## HISTORIC AND DESIGN REVIEW COMMISSION

**HDRC CASE NO:** 2018-155  
**COMMON NAME:** 915 S LAREDO  
**LEGAL DESCRIPTION:** NCB 310 BLK 5 LOT I & E IRR 15.5 FT OF D  
**ZONING:** C-3NA, RIO-7  
**CITY COUNCIL DIST.:** 1  
**APPLICANT:** Judith De Santiago/JD Commercial Realty  
**OWNER:** RGS Holdings, LLC  
**TYPE OF WORK:** New construction of a two story, commercial structure  
**APPLICATION RECEIVED:** March 29, 2018  
**60-DAY REVIEW:** May 28, 2018  
**REQUEST:**

The applicant is requesting conceptual approval to construct a two story commercial structure with surface parking at the corner of S Lareda Street and Guadalupe Street, in RIO-7.

1 WEST EXTERIOR ELEVATION  
1/8" = 1'-0"

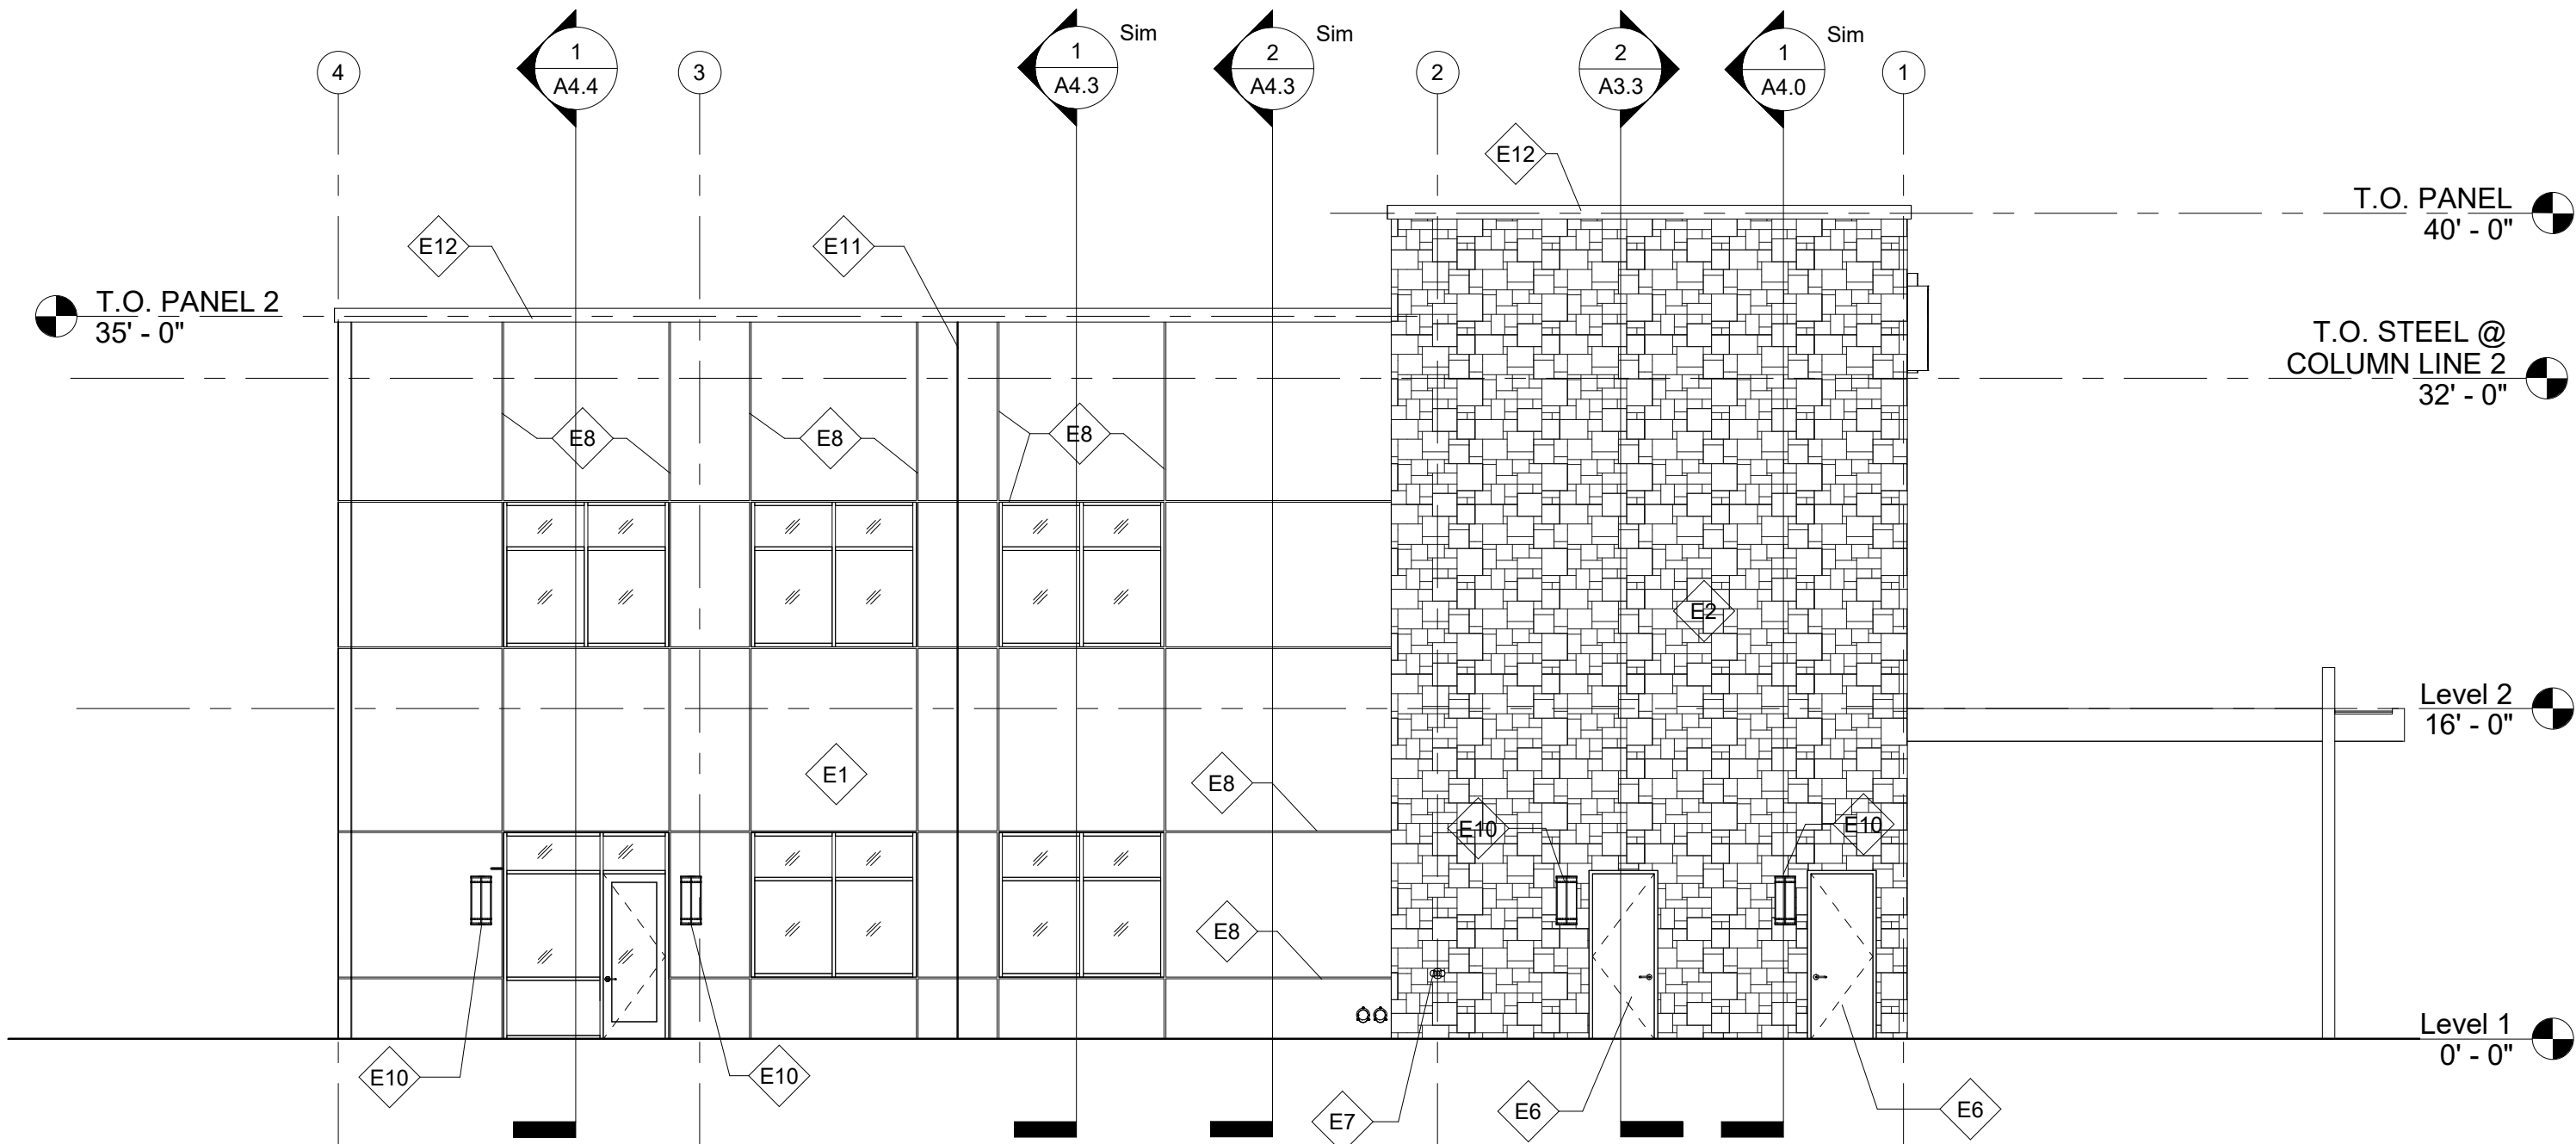
- i. **BUILDING SCALE** – According to the UDC Section 35-674(b) a building shall appear to have a “human scale”. To comply with this, a building must (1) express façade components in ways that will help to establish building scale, (2) align horizontal building elements with others in the blockface to establish building scale, (3) express the distinction between upper and lower levels, (4) in this instance, divide the façade of the building into modules that express traditional and (5) organize the mass of a building to provide solar access to the river. The applicant has incorporated elements into the design to provide a human scale including pedestrian scaled windows and storefront systems and human scaled materials. Generally, this is consistent with the UDC.

- l. **ENTRANCES** – As noted in finding f, the applicant has proposed the primary entrances to be toward the interior of the site. The UDC Section 35-674(e)(3) notes that entrances shall be the most prominent on the street side, shall be placed as to be highly visible, that the scale of the entrance is determined by the prominence of the function and or amount of use, that entrances shall have a change in material and/or wall plane and that entrances should not use excessive storefront systems. The applicant’s proposed entrances are not consistent with the UDC.

- iii. That the applicant develop landscaping and lighting plans prior to returning for final approval as noted in findings g and n.
- iv. That all windows be recessed at least two (2) inches within solid walls and that curtain wall systems shall be designed with modulating features such as projecting mullions as noted in finding k.
